CALIFORNIA DIVISION OF MINES AND GEOLOGY
Supplement ^{#2} to Fault Evaluation Report FER-13

March 23, 1978

1. Name of fault: Ventura fault.

FIGURE 1
LOCATION OF SITE-SPECIFIC INVESTIGATIONS,
YEBERA FAULT.

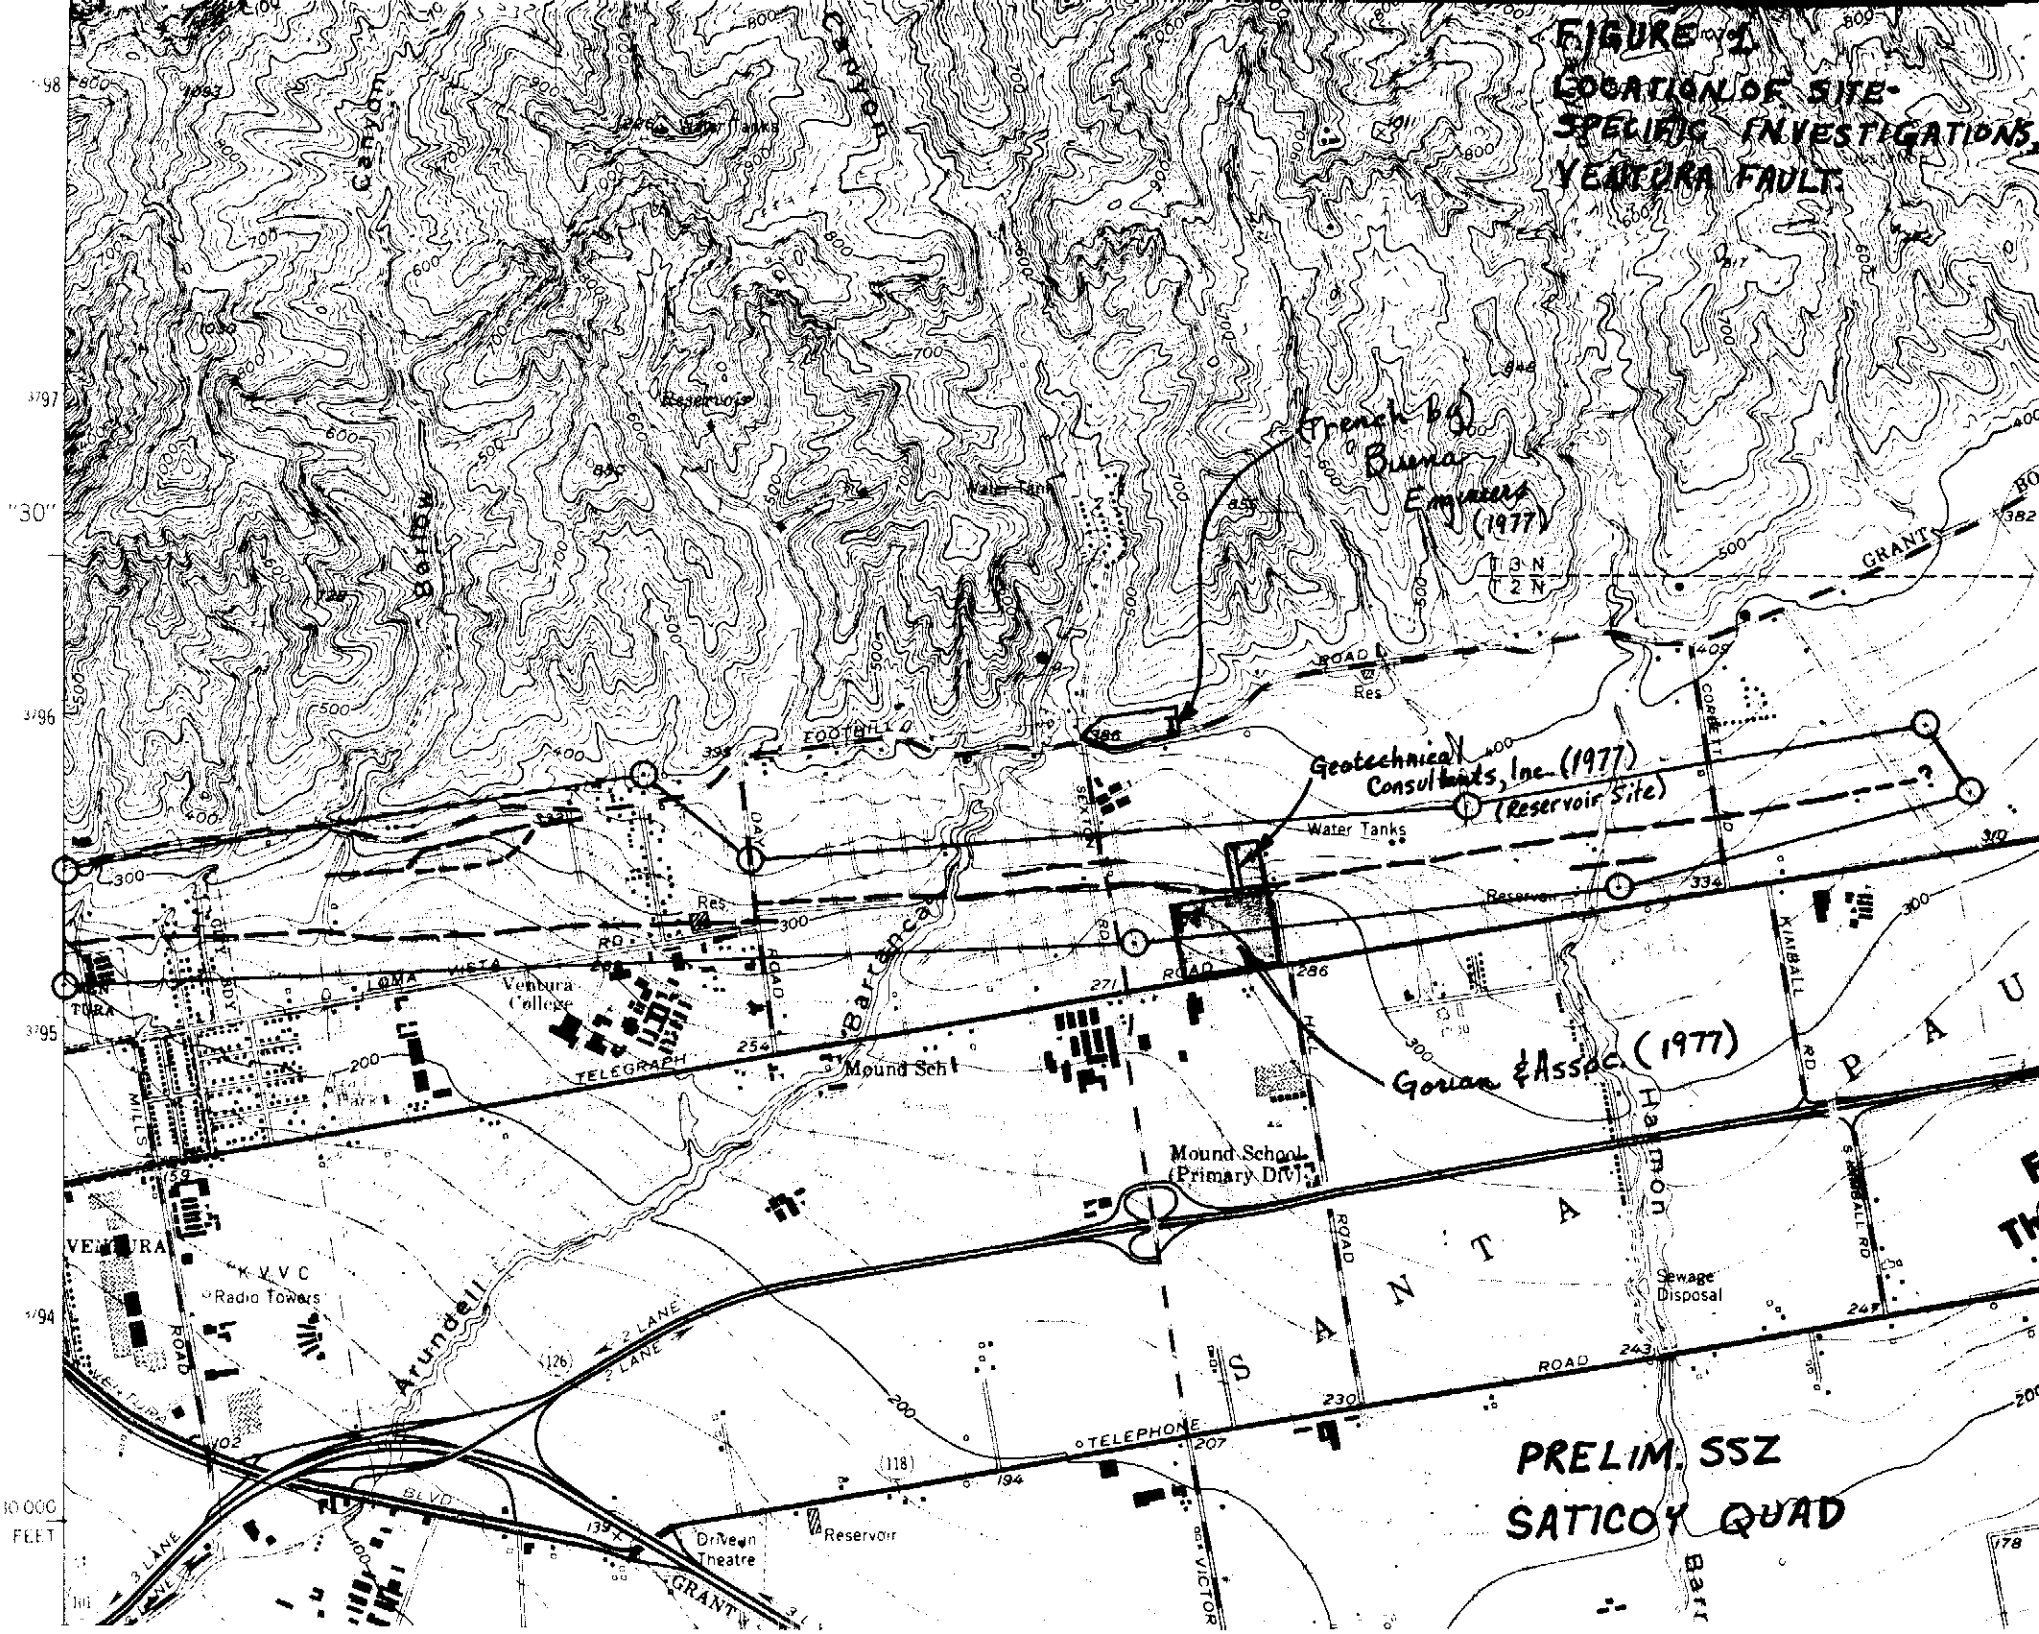
b. Gorian Associates (1977) report -- this study (figure 1) consists of a 200-foot long, north-south trench excavated about 100 feet south of the base of the topographic escarpment shown by Sarna-Wojcicki, et al. (1976). No evidence of faulting was reported. A sample of wood collected from a depth of 4.3 feet was dated radiometrically as being 450 ± 220 ybp (Smith, 1978).

c. Buena Engineers, Inc. (1977) report -- the site studied lies just north of Foothill Road, a quarter-mile north of the Ventura fault (figure 1). Approximately 200 feet of trenches were excavated to a depth of 5 or 6 feet in a north-south direction. Although the trench logs

**FIGURE 2
LOCATION OF SITE-SPECIFIC
INVESTIGATIONS, VENTURA FAULT**

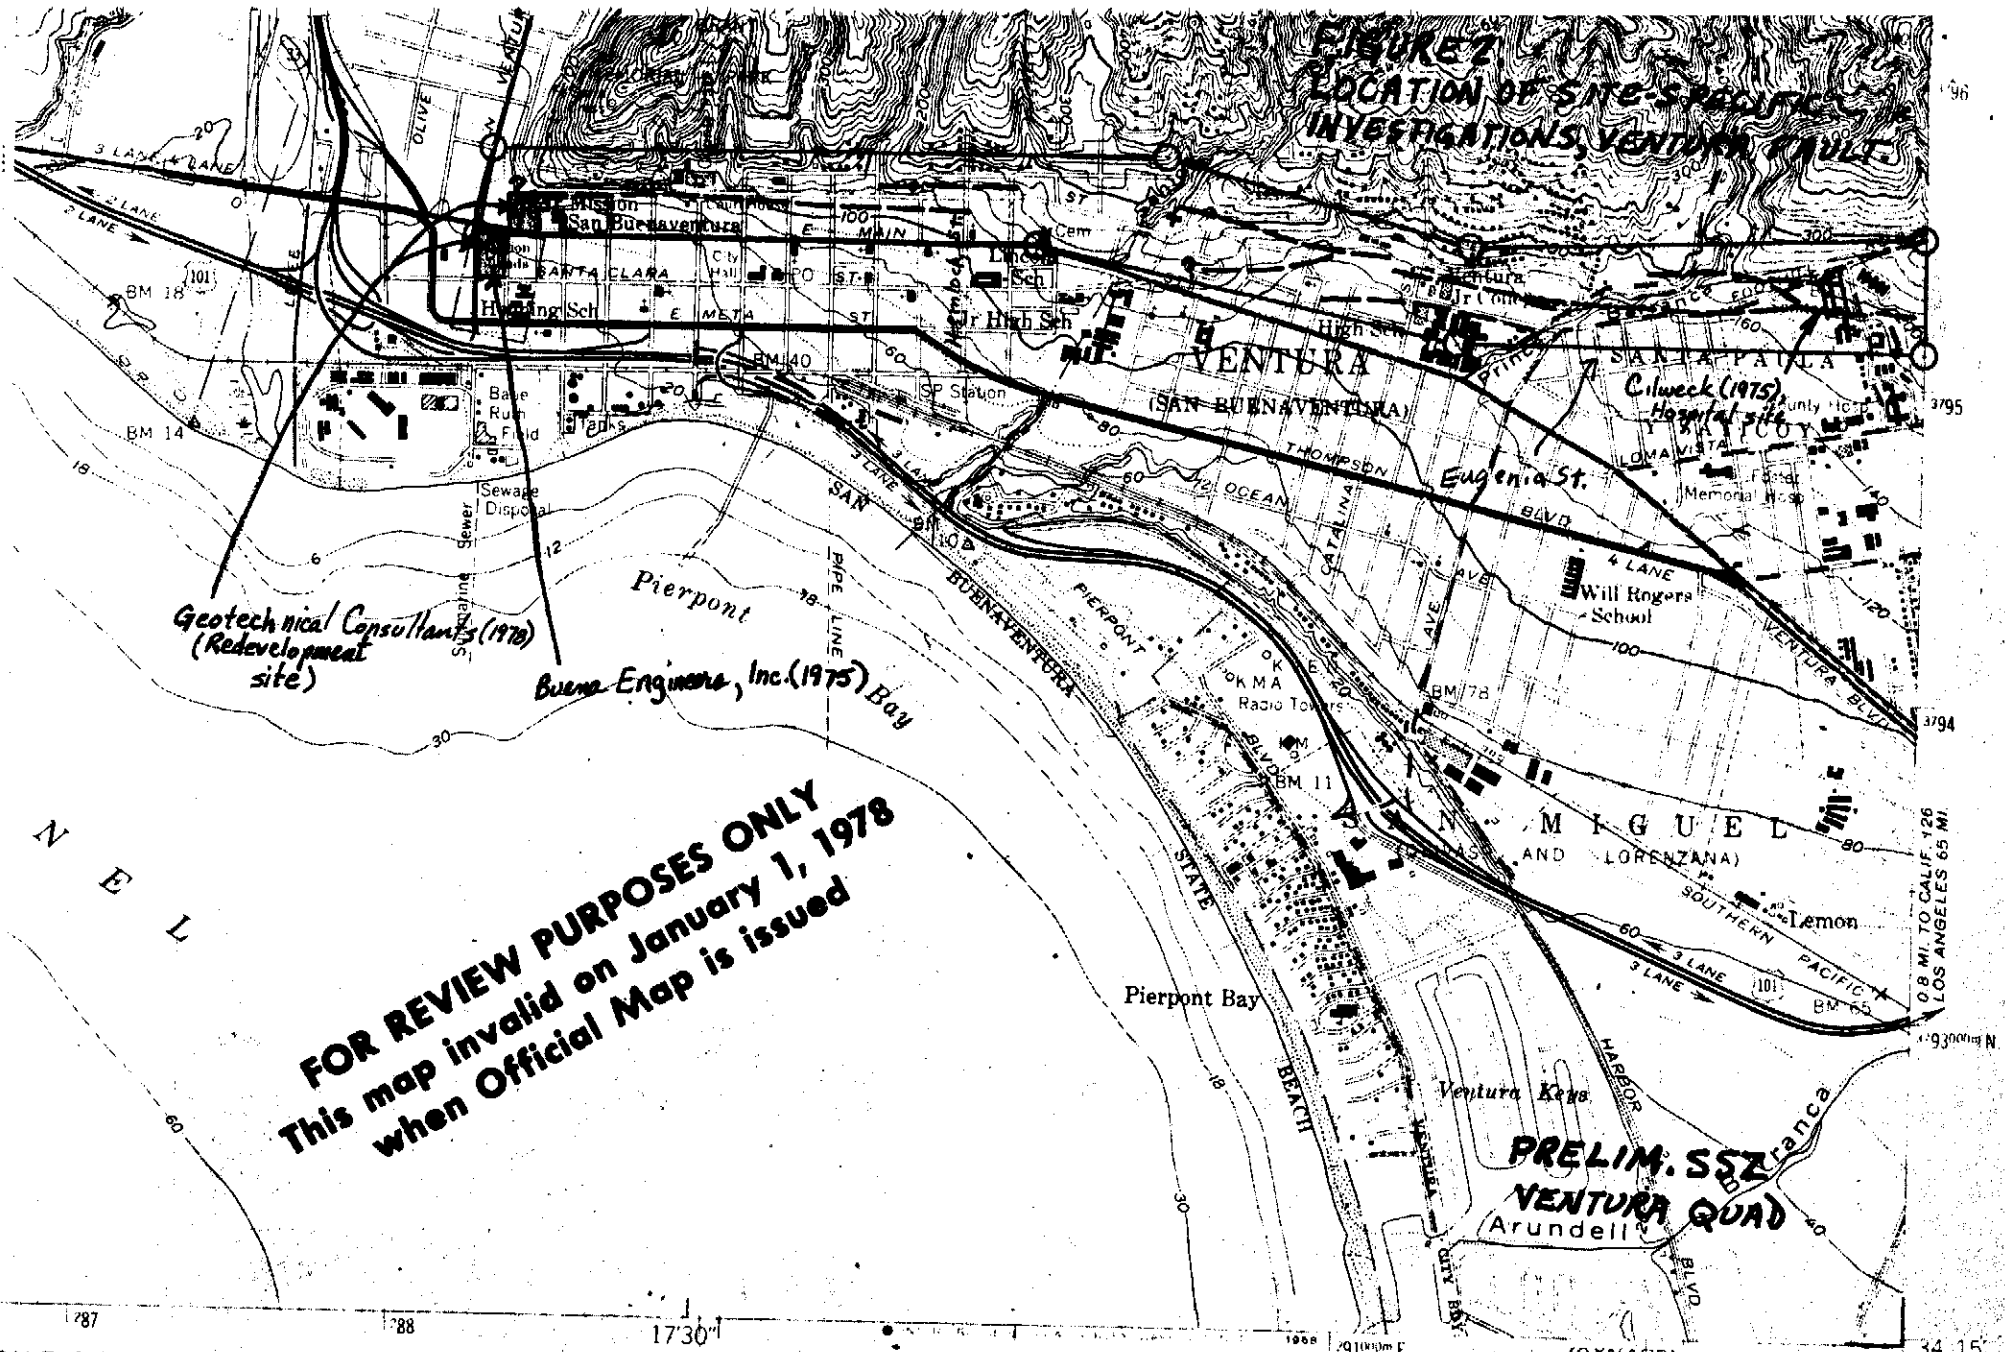
e. Geotechnical Consultants (1978) -- This report is based on detailed investigations of the Mission Plaza Redevelopment site at the west end of the Ventura fault (figure 2). The investigation consisted of a series of short, discontinuous trenches, 6 drill holes (partly logged visually), and 4 boreholes. The steepness of the topography and existing structures (walls, stairs, etc.), landscaping and fill prevented continuous trenching across the east-west topographic escarpment, believed by Sarna-Wojcicki, et al. (1976) to be the surface expression of the Ventura fault. Based on their observations and interpretations, Geotechnical Consultants (p. 15) believe that the escarpment origin is "unrelated to an active Ventura fault as postulated by the California Division of Mines and Geology and the U.S.G.S." They concluded that there was no hazard from surface fault rupture at the investigated site. It was their opinion (p. 16) that "the escarpment represents a semi-dip slope developed by erosional modification...coincident with the formation of the Ventura Avenue anticline." What they do not explain is 1) what erosional mechanism (e.g. wave cut face or stream bank erosion) produced the escarpment and 2) why no evidence exists for such a process at the site.

f. Buena Engineers, Inc. (1975) -- This report covers the portion of the Mission Plaza Redevelopment site south of Main Street (figure 2). It is a non-definitive study based on shallow boreholes. The report provides no correlation sections and concludes that there is no fault hazard.

Supplement to FER-13,
Figure 3. Log of Trench 1 (copied from Cilweck, 1975, Fig. 5)

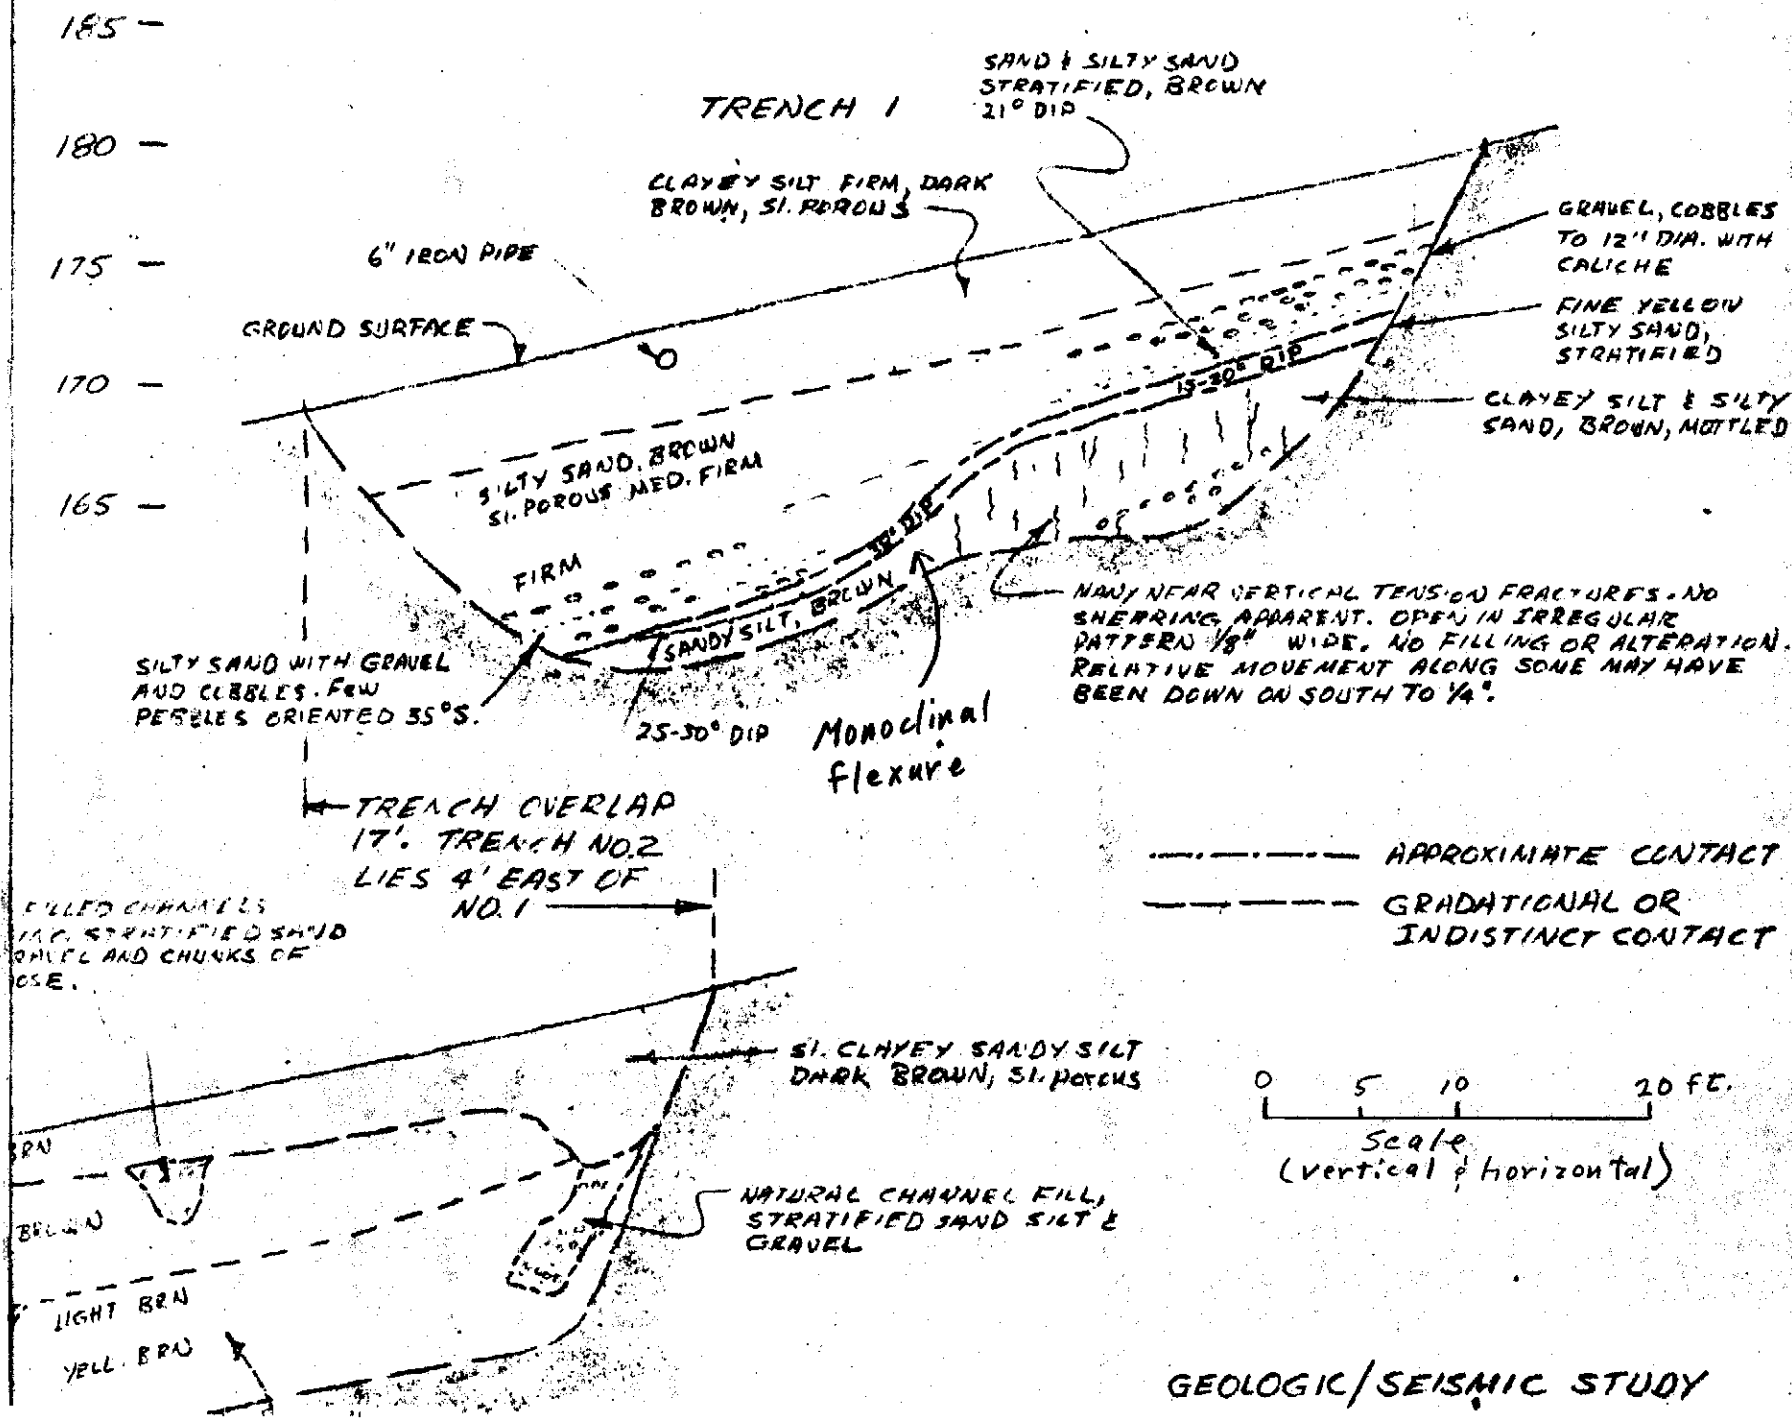
Two of the three trenches were located on or across the escarpment and both showed monoclinal flexing. Trench 1, located west of Hillmont Ave.

and near the toe of the escarpment showed a sharp, small-scale flexure

as shown on figure 3 herein. A larger, faulted monocline was also
